ADDENDUM #2

ISSUED BY EDiS COMPANY
110 S. POPLAR STREET, WILMINGTON, DE 19801

RED CLAY CONSOLIDATED SCHOOL DISTRICT
A. I. DuPont Middle School
HVAC RENOVATION
3130 KENNETT PIKE
WILMINGTON, DELAWARE 19807

E9.12
SHEET NO.
SK-E.17

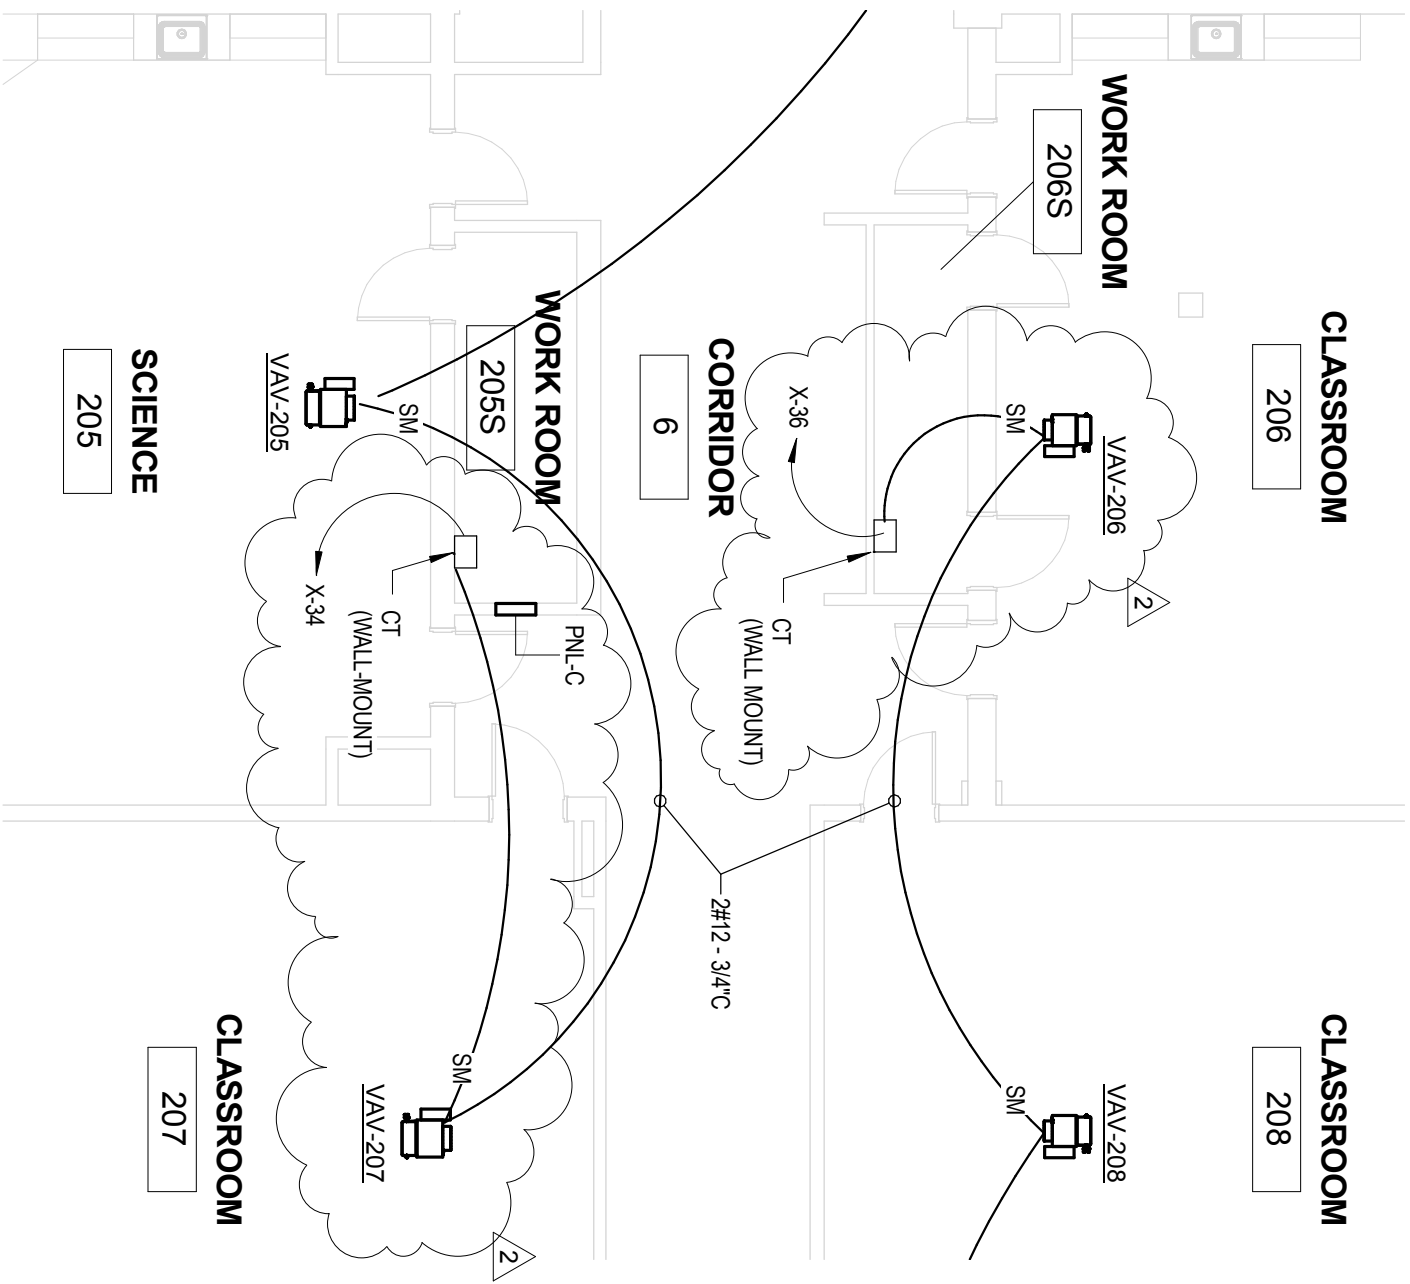
10. Drawing E9.12 – Move (2) CTs from ceiling spaces and into Work Room 205S and Work Room 206S, respectively. See sketch SK-E.17.
11. Drawing E9.13 – Move CT out of ceiling space and relocate to Stage 217. See sketch SK-E.18.

1
SK-E.21

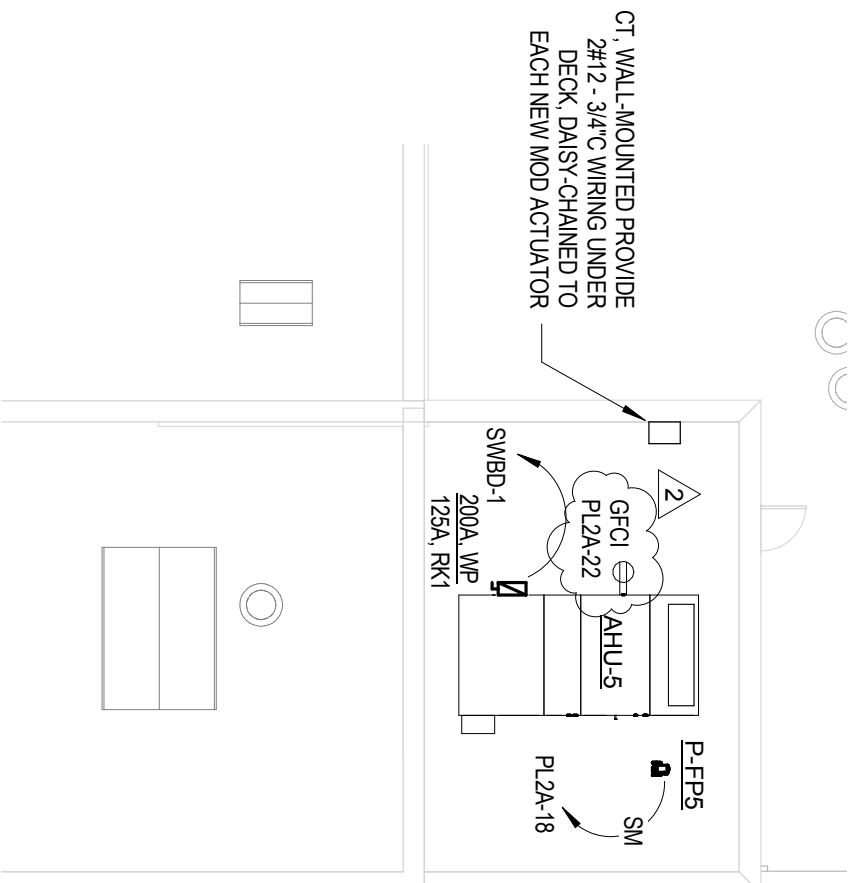
14. Drawing E9.16 – Add GFCI at AHU-5. See sketch SK-E.21.
15. Drawing E9.15 – Add junction box for ATC power supply and corrected circuits to UV-1 in Rm 316. See sketch SK-E.22.

05/15/15
DATE
14036
PROJECT NO.
E9.1
SHEET NO.
SK-E.28

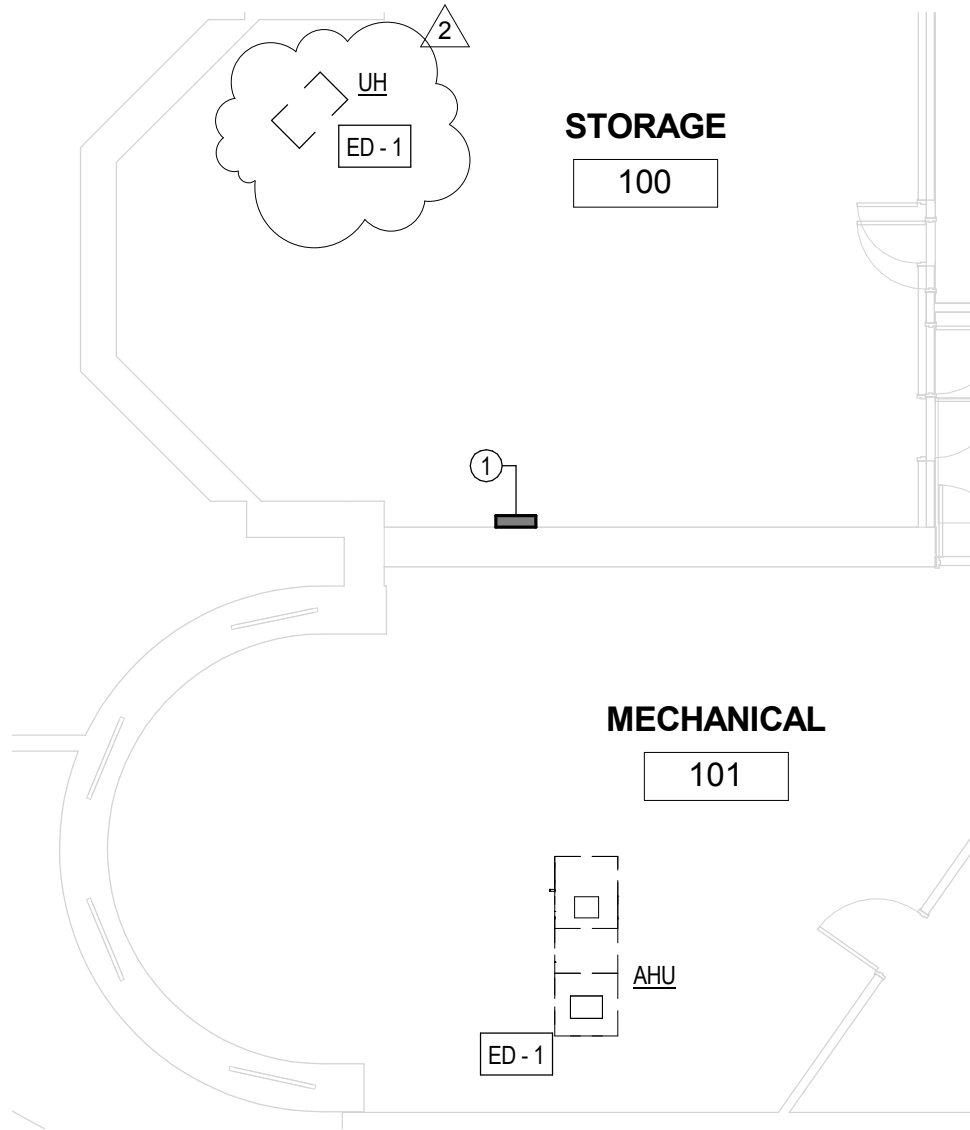
19. Drawing SK-E.26 – Revised panel description.
20. Drawing SK-E.27 – Revised panel description.
21. Drawing E9.1 – Add demolition of unit heater circuit. See sketch SK-E.28.

1
SK-E.29

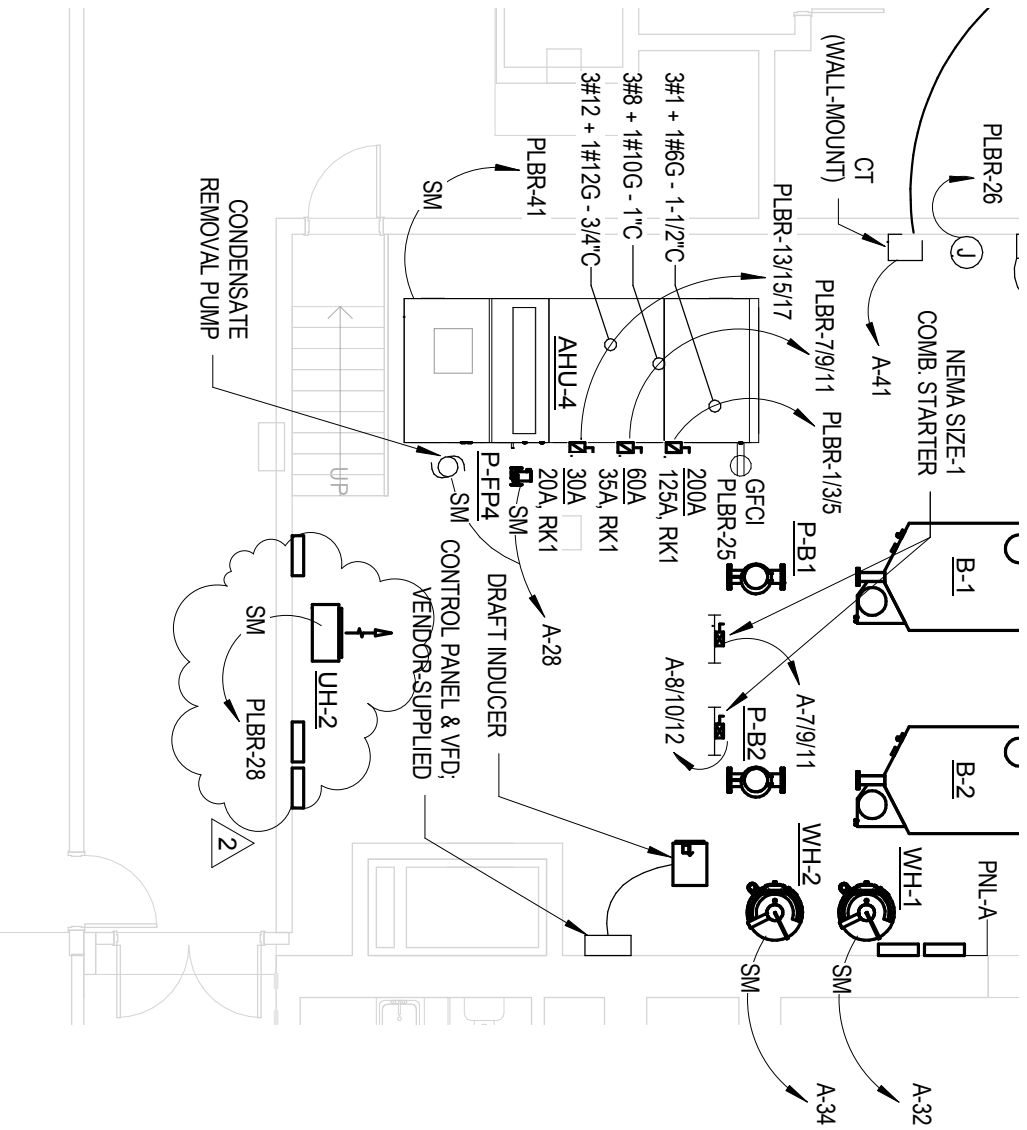
22. Drawing E9.0 – Revise single-line diagram. See sketch SK-E.29.
23. Drawing E9.10 – Add power circuits to unit heaters. See sketch SK-E.30.
24. Drawing E9.10 – Add power circuit to unit heater. See sketch SK-E.31.

05/15/15 E9.11
DATE SHEET NO.
14036 SK-E.32
PROJECT NO.

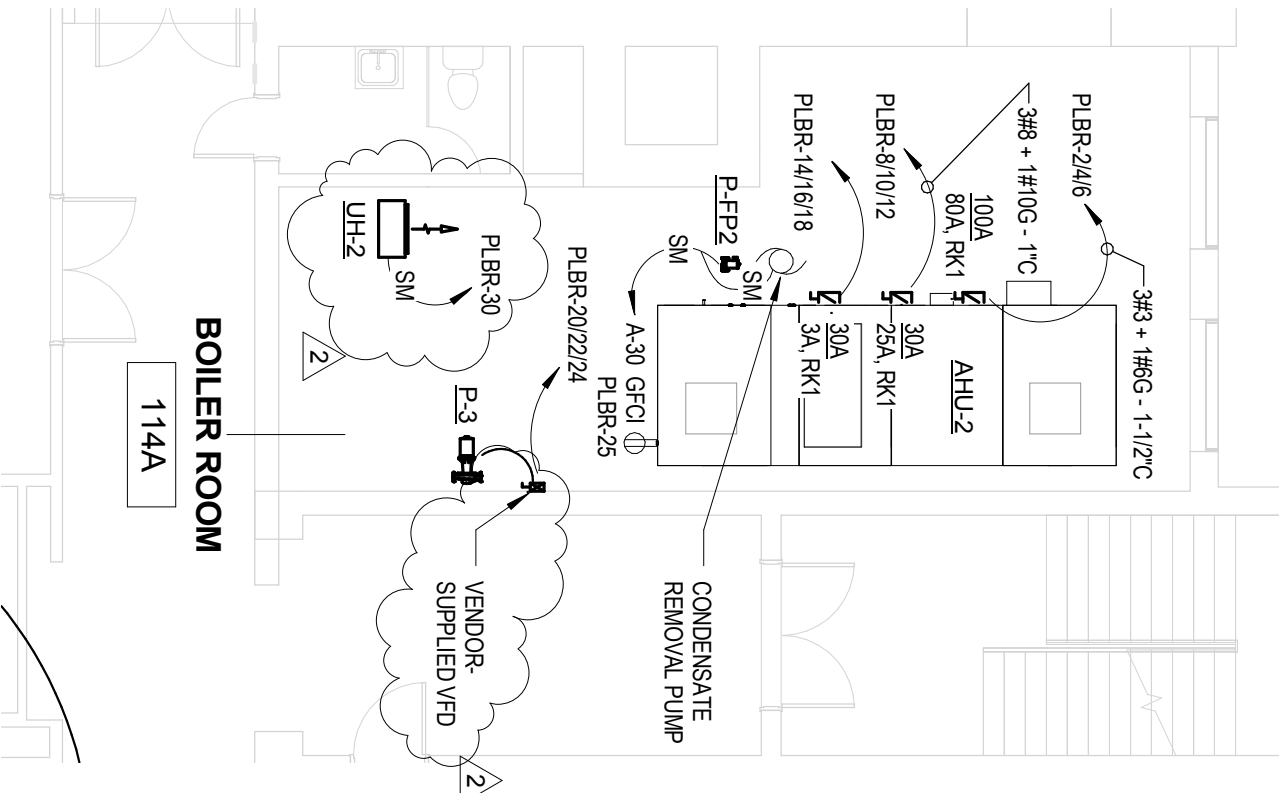
25. Drawing E9.11 – Add power circuit to unit heater. Revise power note to P-3. See sketch SK-E.32.
